Subject: SUPPLEMENTAL INFORMATION REGARDING REVISION 7 OF THE
RH-TRU 72-B SHIPPING PACKAGE APPLICATION, DOCKET NO. 71-9212

Summary of RH-TRU 72-B Shielding Evaluations and Satisfaction of Dose Rate Limits

Responses to NRC Request for Supplemental Information (RSI) on Revision 7 of the RH-TRU 72-B Safety Analysis Report (SAR), Revision 3 of the Remote-Handled Transuranic Waste Authorized Methods for Payload Control (RH-TRAMPAC), and Revision 3 of the RH-TRU Payload Appendices

Figure RSI 5-1.1 – MCNP Geometries for NCT and HAC Analyses

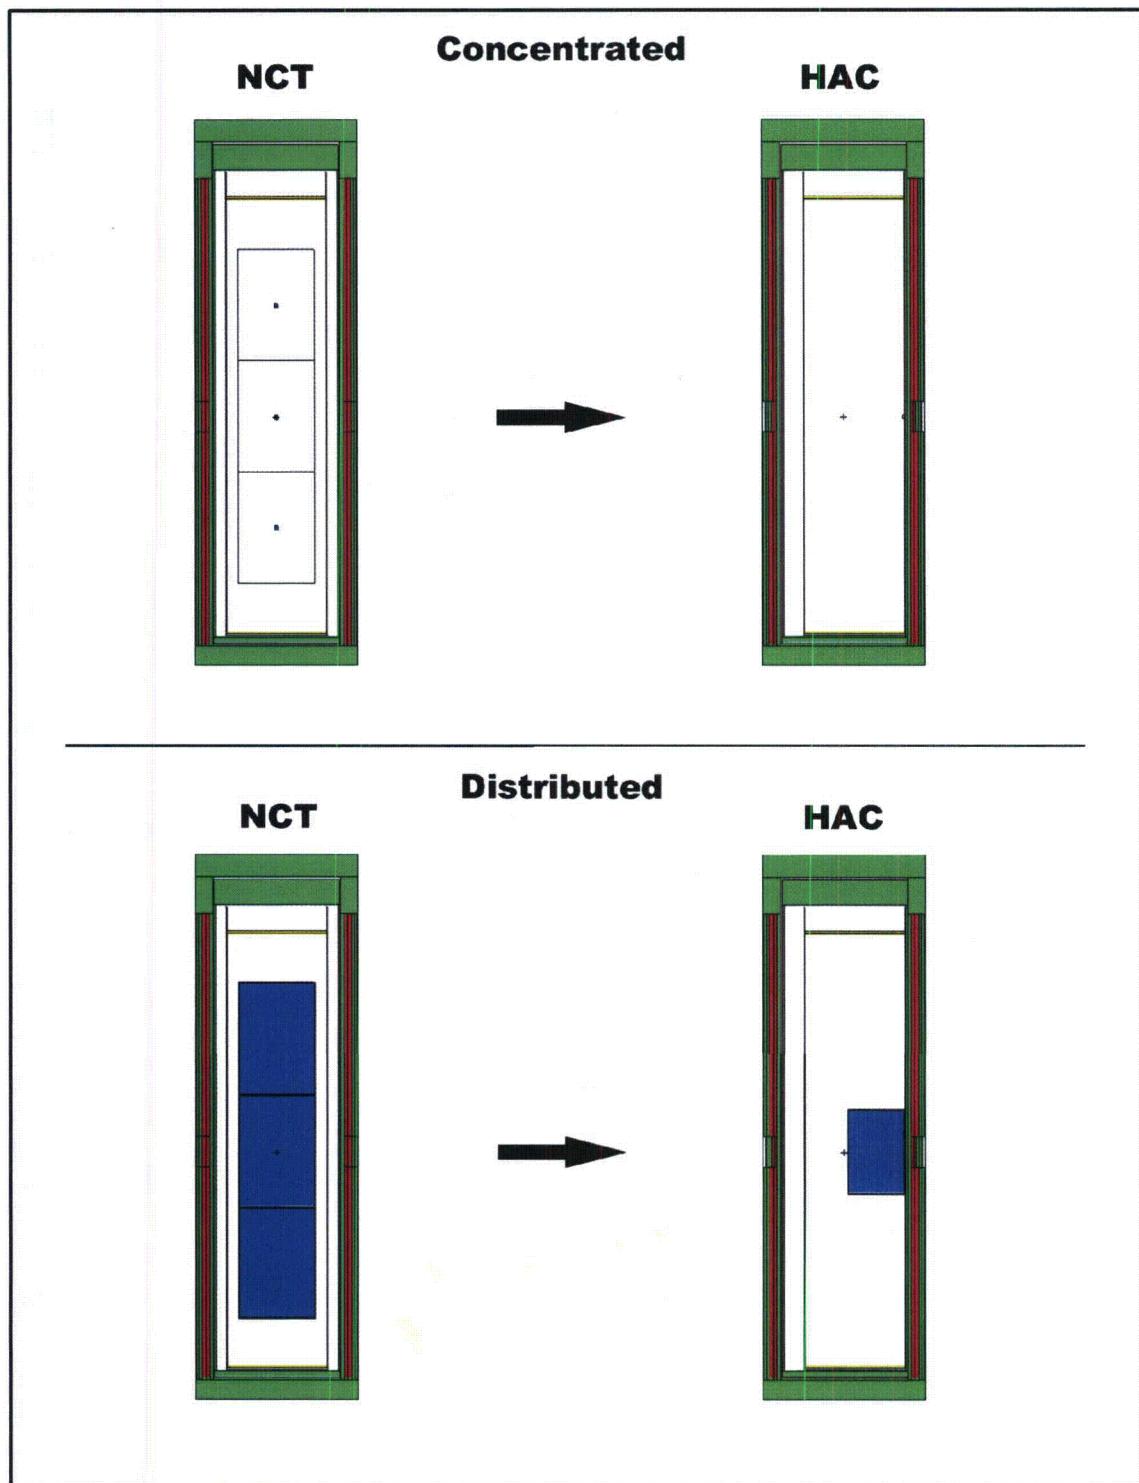
- 5-1 Provide analyses, or justification, for the determination of the limiting dose rate location(s) for all allowable source geometries, energies, and canister configurations.

Section 5.5, "Activity Limits," states: "Since the results in Section 5.4, *Shielding Evaluation*, demonstrate that contents meeting the NCT limits at 2 meters will meet NCT surface and HAC at 1 meter limits, maximum activity was determined only for NCT."

Section 5.4 appears to only include analyses for concentrated Co-60 and Cf-252 whereas Section 5.5 includes activity limits for both distributed and concentrated sources of gammas from 0.5-10 MeV and neutrons 0.1-15 MeV. The staff requests that the applicant provide appropriate analyses to support the conclusion that the limiting conditions for all allowable contents is NCT at 2 meters (versus NCT surface dose rate limits or HAC dose rate limits for distributed sources). For example, in a similar package, the surface dose rate regulations were the most limiting for lower energy gammas (less than 1 MeV), and certain distributed source configurations were limited by HAC conditions. The applicant should provide analyses justifying the limiting dose rate location(s) that encompasses both source geometries for all canister configurations and the range of allowable gamma and neutron energies.

Additional RH-TRU Waste Canister HAC shielding evaluations, like that presented in RH-TRU 72-B SAR Table 5.4-4 for Co-60 and Cf-252, were performed for each discrete gamma and neutron energy listed in SAR Table 5.5-1 in both concentrated and distributed source forms to determine the allowable activity associated with the 1 rem/hr at 1 meter HAC dose rate limit. The results were subsequently compared with the allowable activity to reach the NCT at 2 meter dose rate limit listed in SAR Table 5.5-2 in addition to the allowable activity to reach the NCT at surface dose rate limit. The comparison, details of which are provided below, demonstrate that the NCT at 2 meter dose rate is limiting such that NCT dose rate compliance ensures that HAC dose rate requirements are satisfied.

The HAC concentrated source evaluations implemented the extremely conservative geometry assumptions utilized for the Co-60 and Cf-252 evaluations depicted in SAR Figure 5.3-2. The HAC distributed source evaluations similarly implemented a conservative geometry assumption that concentrates the distributed sources down to a single, approximately 16-gal, volume in line with the puncture damage location that minimizes the shield material thickness and the distance to the 1-meter detector. The NCT and HAC geometry models implemented in the MCNP evaluations are shown in Figure RSI 5-1.1.

Tables RSI 5-1.1 through RSI 5-1.4 provide the resulting concentrated and distributed gamma and neutron source dose rates for NCT and HAC, based on the associated activity for each case that is most limiting; namely, the activity required to meet the NCT at 2 meter dose rate limit. In all cases, except for the lowest energy concentrated gamma source, the NCT at 2 meter dose rate is limiting by a reasonably large margin in comparison to the NCT at surface and/or HAC at 1 meter dose rates. The low-energy concentrated gamma HAC result is unrealistically high because the large quantity of low-energy gamma required to challenge the NCT at 2 meter dose rate would necessarily be somewhat distributed initially and could not subsequently coalesce into a single point, as assumed in the HAC analysis, and would therefore have a lower HAC dose rate more consistent with the distributed low-energy gamma source case. Therefore, the use of the NCT at 2 meter dose rate to ensure compliance with the HAC dose rate is justified over applicable source types, distributions, and energies.

Figure RSI 3-1.1 – Typical Convective Flow Pattern between Concentric Cylinders

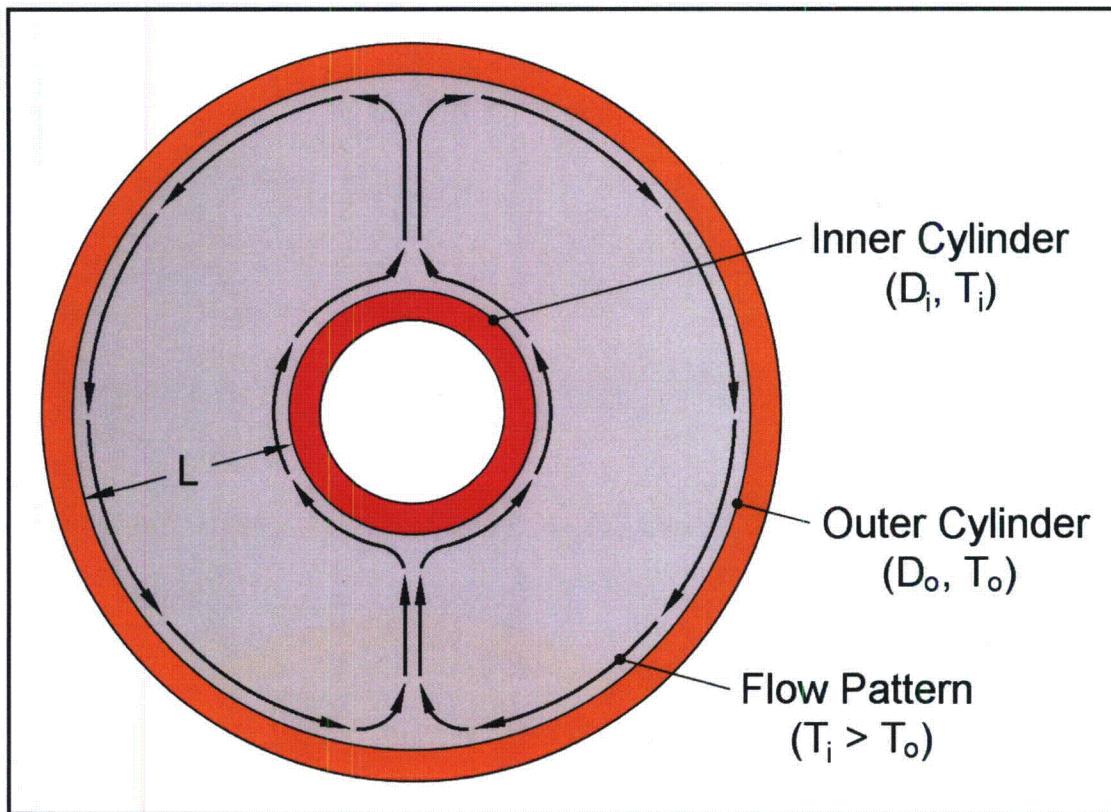
- 3-1 Provide adequate explanation and justification to neglect internal convection in the thermal evaluation of the RH-TRU 72-B waste shipping package during HAC (fire).

Page 3.4-1 of the SAR states that “Consistent with NRC-accepted thermal analysis methodology, internal convection between bodies is conservatively ignored.”

Neglecting internal convection during HAC may underestimate package maximum temperatures and pressures because during the fire event internal convection could increase heat transfer from the heat source (fire) to the package internals.

The RH-TRU 72-B waste shipping package is transported horizontally. Natural convection heat transfer across a gap between two long, horizontal concentric cylinders may be evaluated using Equations 3.101 through 3.104 from Eric C. Guyer, *Handbook of Applied Thermal Design*, CRC Press, 1999. When sufficient radial gap is present between the two concentric cylindrical surfaces, and when buoyancy forces are able to overcome viscous forces, natural convection heat transfer will establish a convective flow pattern, such as what is shown in Figure RSI 3-1.1.

Figure RSI 3-1.1 illustrates the condition where the inside cylinder is hotter than the outside cylinder. If the reverse is true, then the convective flow pattern would be reversed from what is shown.

Figure RSIO 5-9.1 – Effect of Zirconium vs Void in Source Region for Neutrons

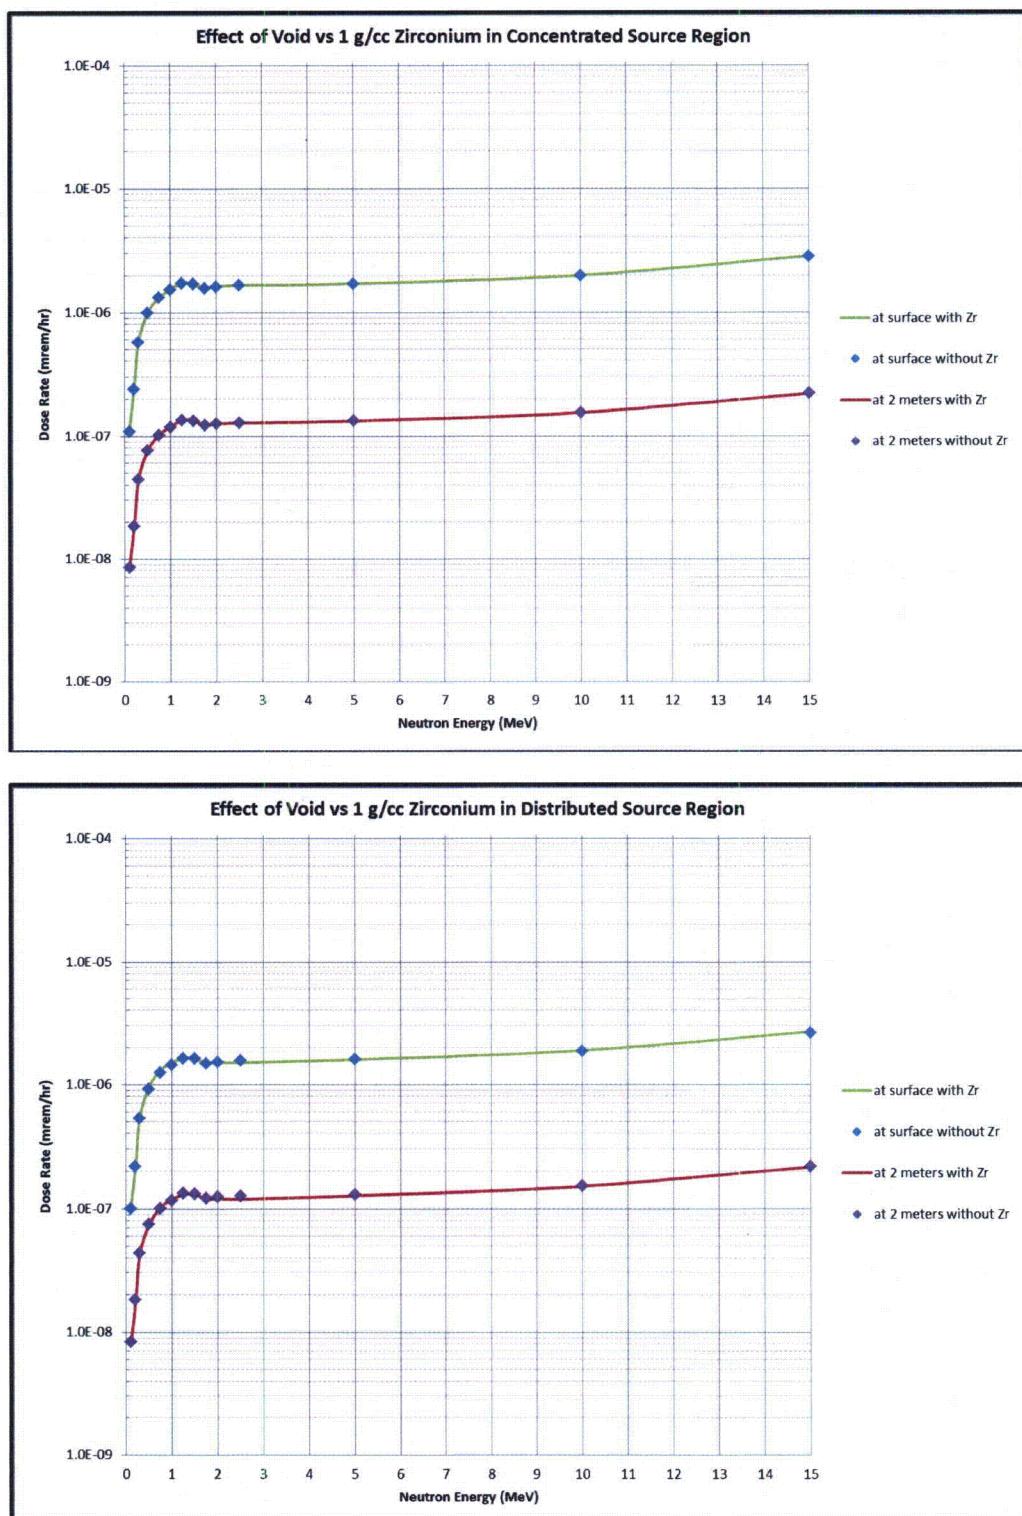
- 5-9 Provide additional information on the assumptions used with respect to self-shielding in the neutron source analyses.

Section 5.5 states: “For distributed neutron sources, the source was evaluated at a single density, 1 g/cc, which applies to any density in the source range without the use of a DCF since the Zr material does not attenuate neutrons. Therefore, the distributed neutron source has an activity allowable that differs from the concentrated neutron source due to distance attenuation effects alone whereas the distributed gamma source has an activity allowable that differs from the concentrated gamma source due to distance and material attenuation effects.” Justify these statements related to the neutron attenuation. Given the fact that Zr does not attenuate neutrons, discuss why this was chosen for the modeling medium. Describe whether any calculations were performed for a distributed source without any type of material assumed for the source to show that it is equivalent to a distributed source composed of Zr.

Zirconium is used extensively in nuclear reactor designs because it is understood to be largely “invisible” to and minimally interact with neutrons. Due to this fact and the desire to minimize the potential for input/modeling errors by utilizing a common and automated Excel template for the creation of gamma and neutron MCNP input decks, the template source region material was retained as Zr for all analyses. Scoping calculations were performed to ensure that the modeling methodology was appropriate and that significant neutron interaction with the Zr source region material did not occur. Figure RSIO 5-9.1 illustrates that the effect of Zr vs void in the source region for both concentrated and distributed source assumptions (utilizing a density of 1 g/cc) is negligible on the dose rate over the analyzed neutron energy spectrum.
